# CITY OF OREGON CITY

**FILE NO.:** L-01-04

**REQUEST:** Review and Recommendation of Approval of the Oregon City Waterfront Master Plan

**REQUEST:** Preliminary Plan for a phased Planned Unit Development of 29 units on 20 lots (17 single family and 12 multi-family units).

SHEET 4 OF 9

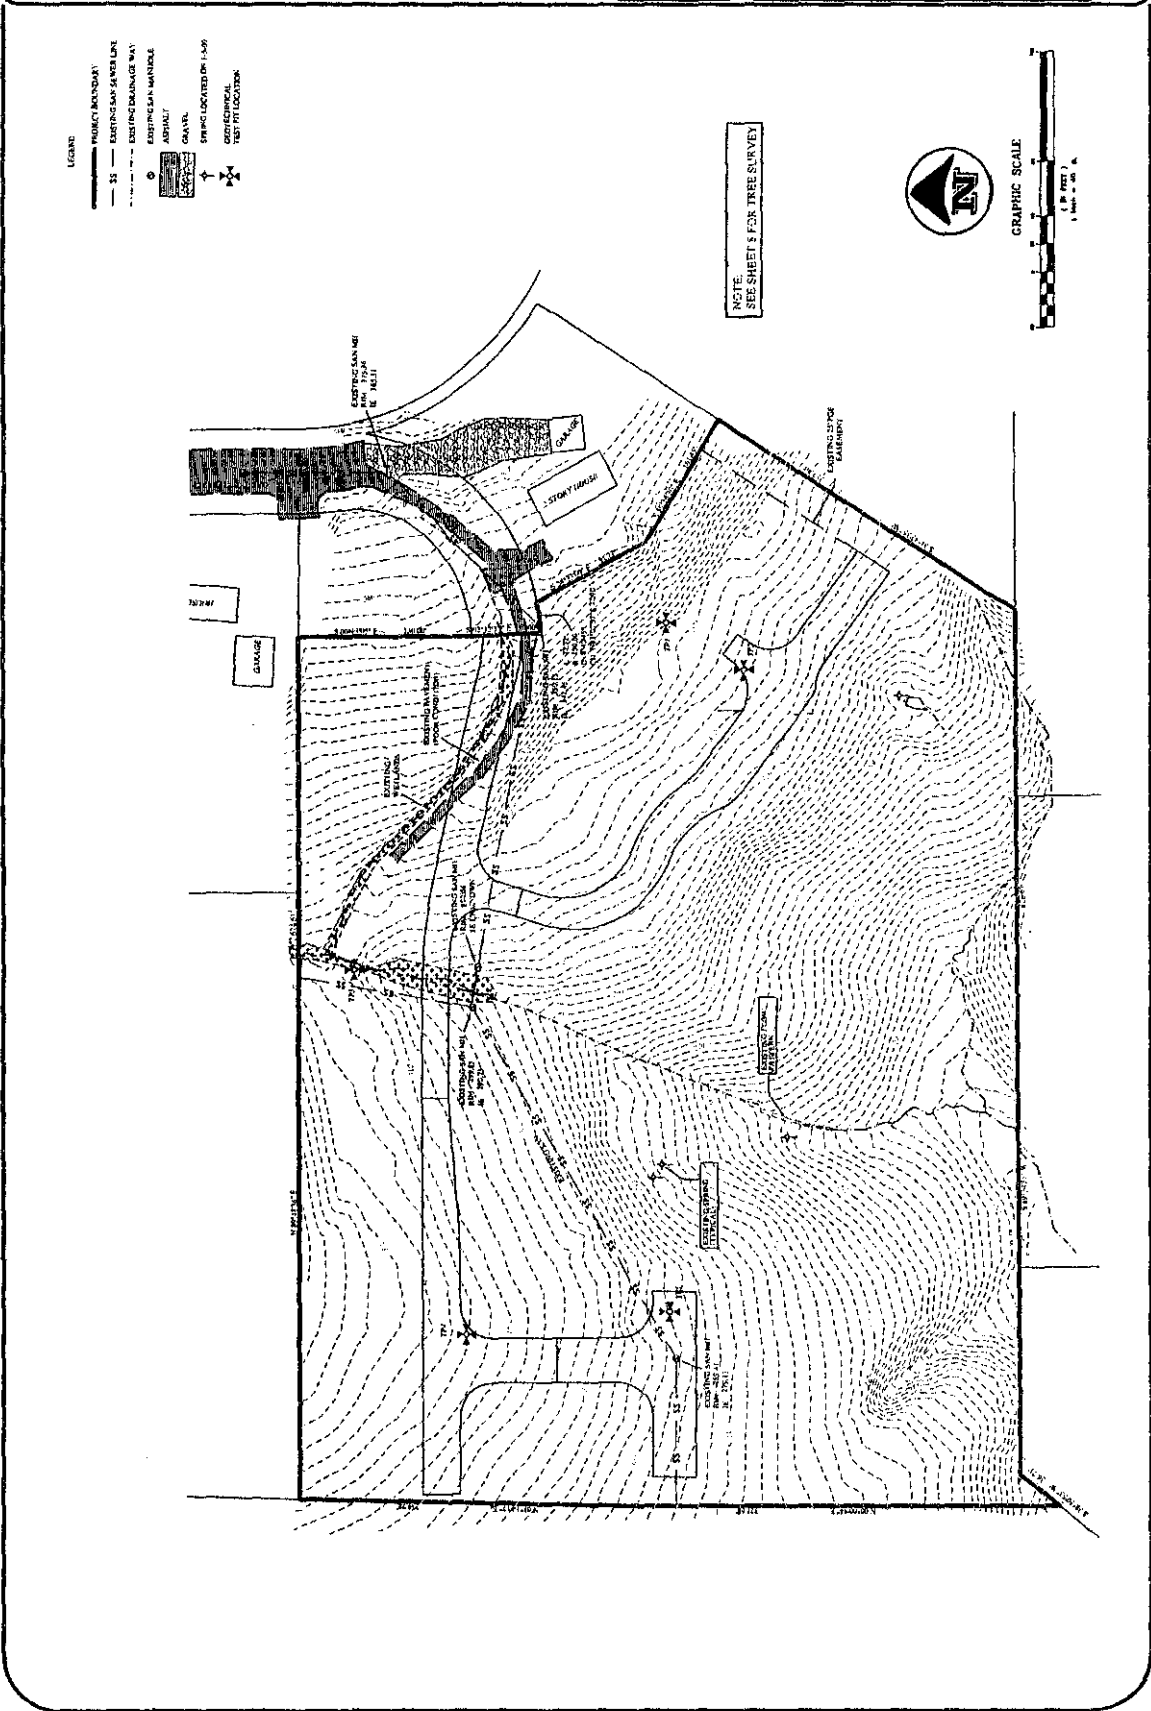
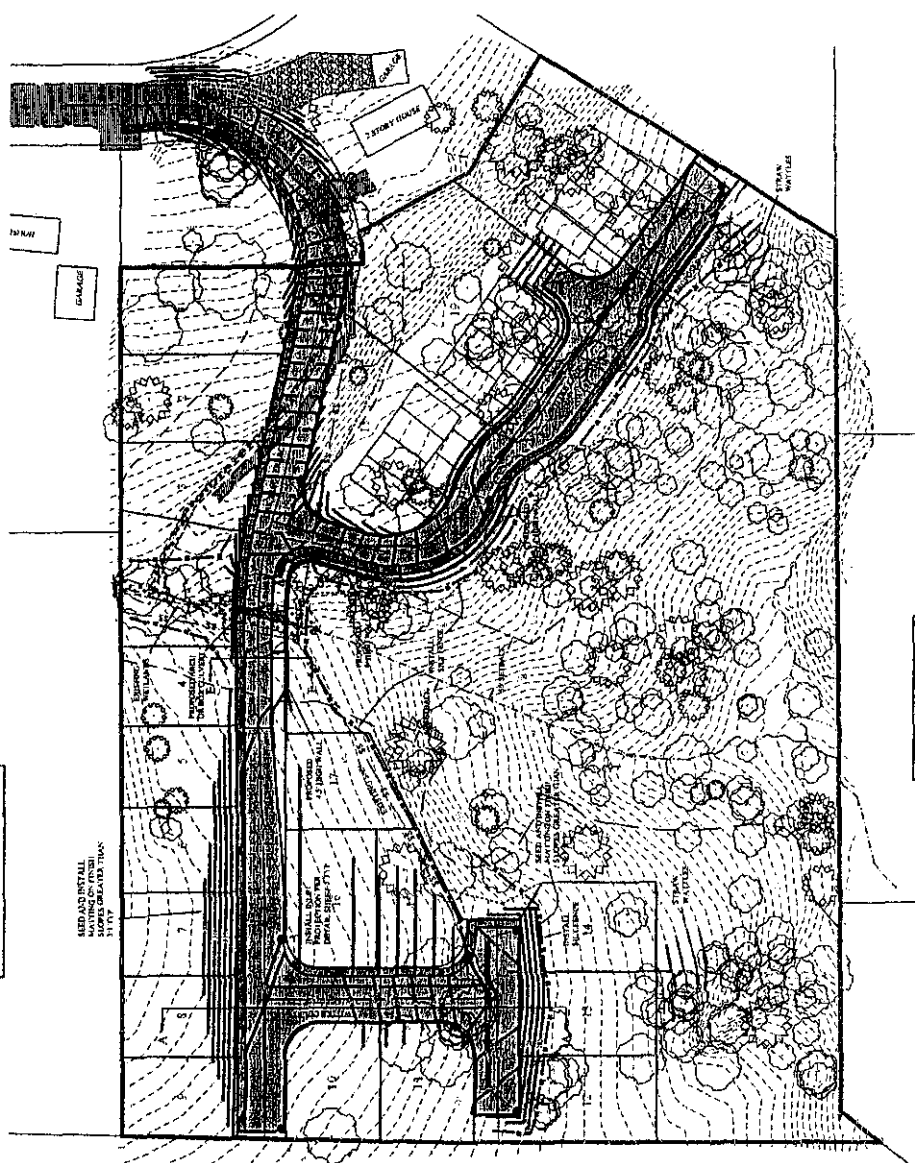
Grading will be required to construct the road and flatten building sites to accommodate the residential units. By installing retaining walls, the applicant is proposing less grading than otherwise would be required. Because of the grading, some trees not within the building footprint but within the grading footprint, will be removed. Staff is satisfied that the minimum number of trees would be removed. The applicant must submit a tree removal and preservation plan, identifying which trees specifically would be removed, and which protected. Methods of protecting the trees during construction shall also be provided.

The applicant's grading plan minimizes cuts and fills by avoiding the steepest portions of the site, modifying standard street widths and slopes, minimizing parking areas, and using retaining walls to achieve workable grades for infrastructure and developable lots. Cut and fill volumes have been thoughtfully controlled to fit the terrain.

The proposed grading plan does not appear to remove the toe of known landslides or slopes greater than 25 percent and therefore meets this standard.

SHEET 8 OF 9

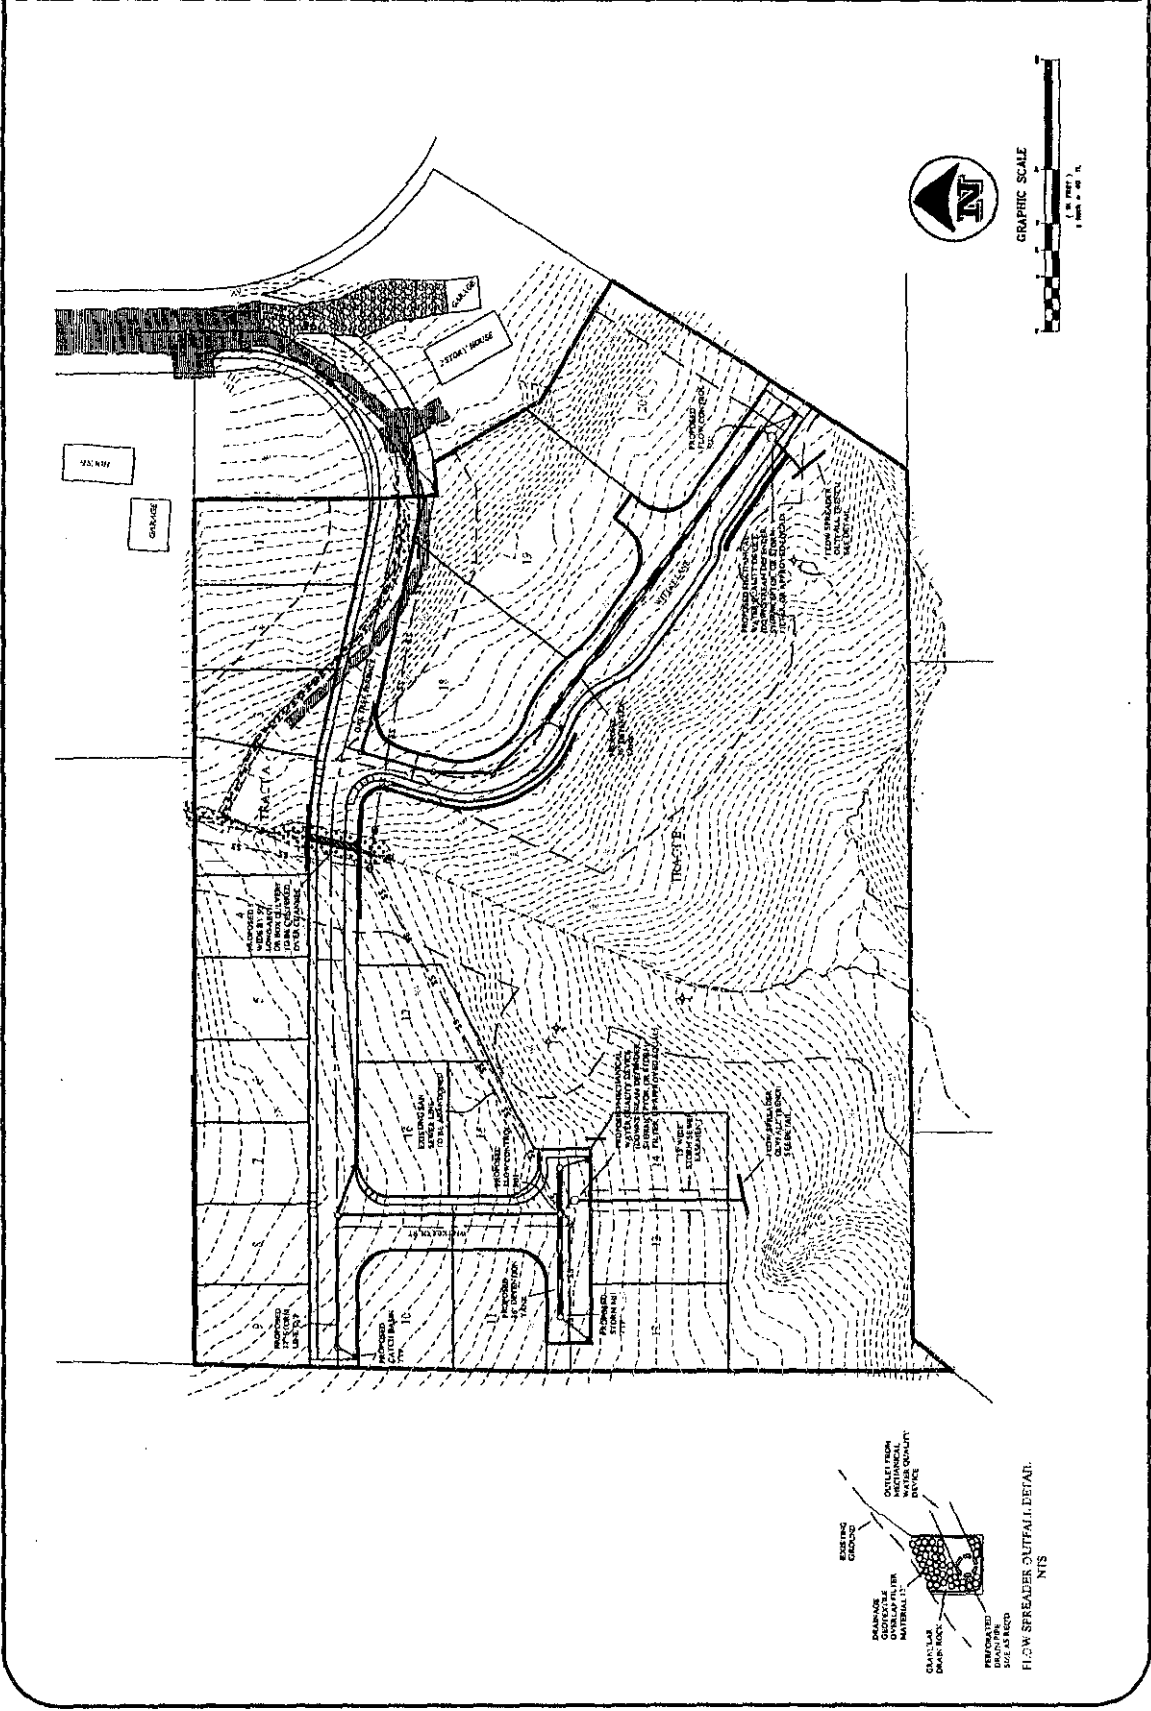
The applicant's Storm Drainage Plan (Sheet 8, Exhibit C) shows a flow spreader outfall trench that would encroach 15 feet into the vegetated corridor at the end of Wittke Lane. The encroachment is necessary to direct the stormwater flow into the natural depression at that location.

**WATER RESOURCES PLAN**  
**OAK TREE P.U.D.**  
OREGON CITY, CLATSOP COUNTY, STATE OF OREGON  
CITY TRS. 7, 7000-01 & 7000-02  
FOR  
**LOWELL WITKE**  
1421 S. OAK TREE AVE. OREGON CITY, OREGON 97143

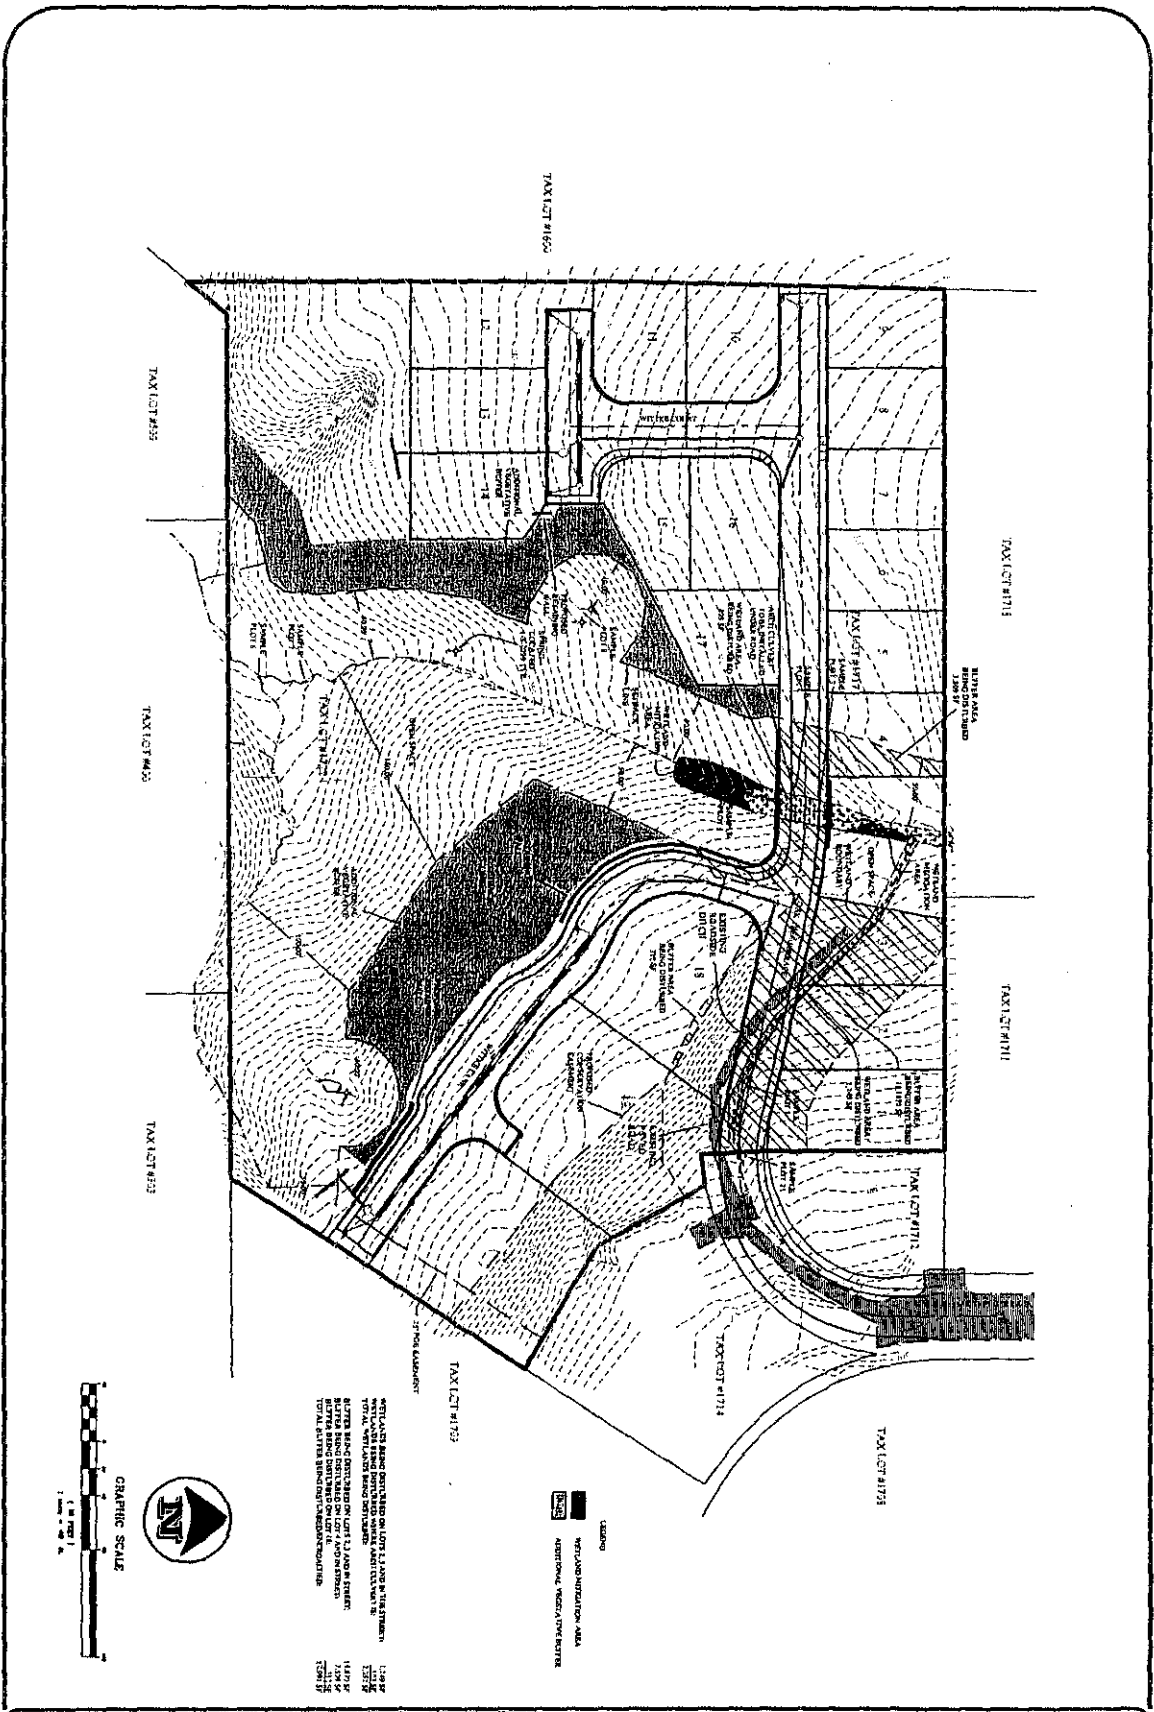
The Water Resources Plan (last sheet of Exhibit C) shows topography at 2-foot intervals and the delineation of the WQRA. The City's Water Quality and Flood Management Areas map boundaries are not shown because for the most part they completely encompass the subject site.

FIGURE 2

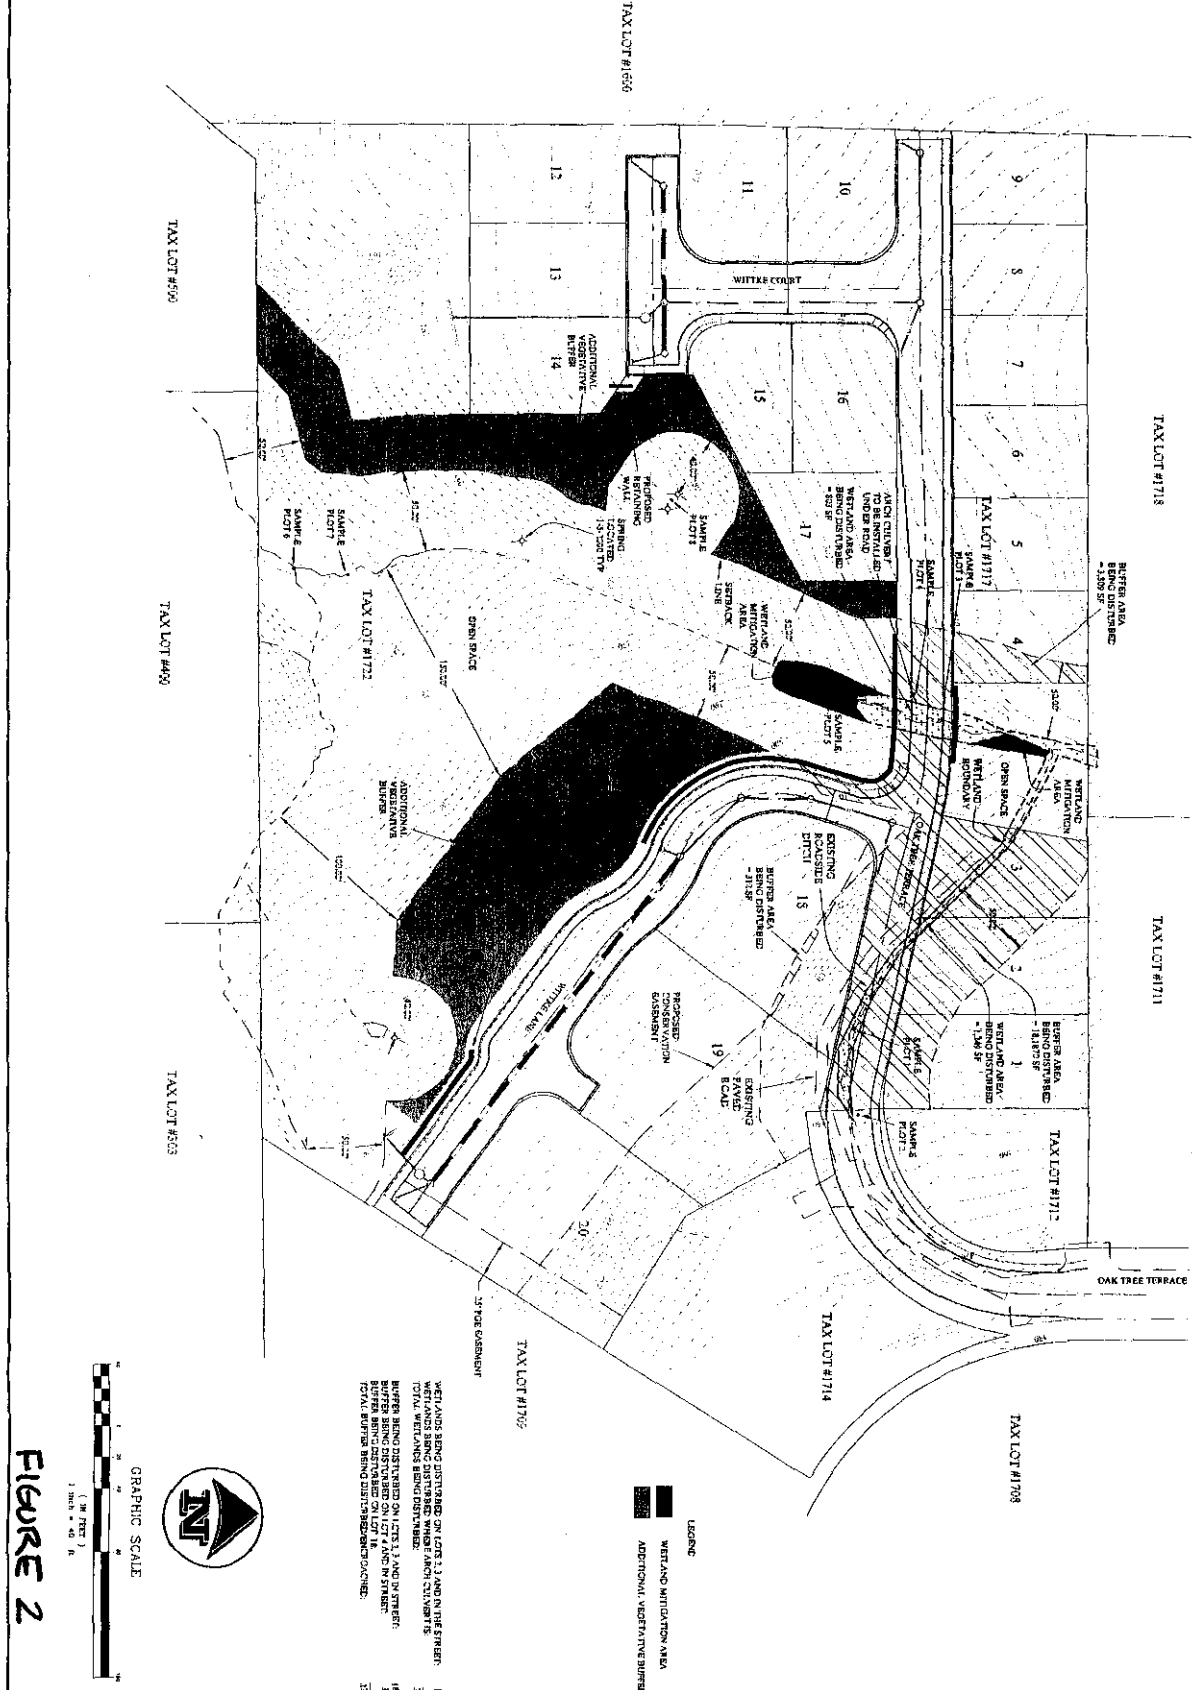
The Water Resources Report Addendum analyzes conceptual mitigation for impacts on the WQRA. The original conceptual mitigation plan contained in the March 2001 report has been voided by the revised PUD design. Wetland impacts were reduced by the revised plan compared to the original PUD design. Retaining part of the wetland on the site allows a better mitigation plan by enhancing the remaining wetland and creating new wetland immediately adjacent. Creation of a wetland area at a 1.5 to 1 ratio requires 3,078 square feet (0.07 acres). The applicant (through the Fishman addendum) proposes a conceptual mitigation plan and vegetated corridor enhancement plan at this stage. Figures 2 and 3 in the Addendum show the proposed mitigation areas.

Oregon City code 17.49.050(G)(1) requires a map that delineates the water quality resource areas, including the protected water features and the vegetated corridors. Figure 2 shows the revised water resource map; the March 2001 report attempted to identify features that met wetland criteria defined by the Division of State Lands and the US Army Corps of Engineers, and also as defined by the City of Oregon City in its Water Resources Overlay District Water Quality Resource Area Standards. The revised figure treats all water resources on the site as jurisdictional, even though not all of them meet Division of State Lands wetland determination criteria or "waters of the state" criteria or the definitions in the standards. Vegetated corridors have been mapped and are 40 feet from the springs; 50 feet from the delineated wetland, and range from 50 feet to 150 feet in steep slope areas from the two unnamed drainages on the site. It should be noted that a portion of the 50 foot vegetated corridor around the delineated wetland is proposed for filling. Proposed encroachment into the vegetated corridors on the site are as follows:
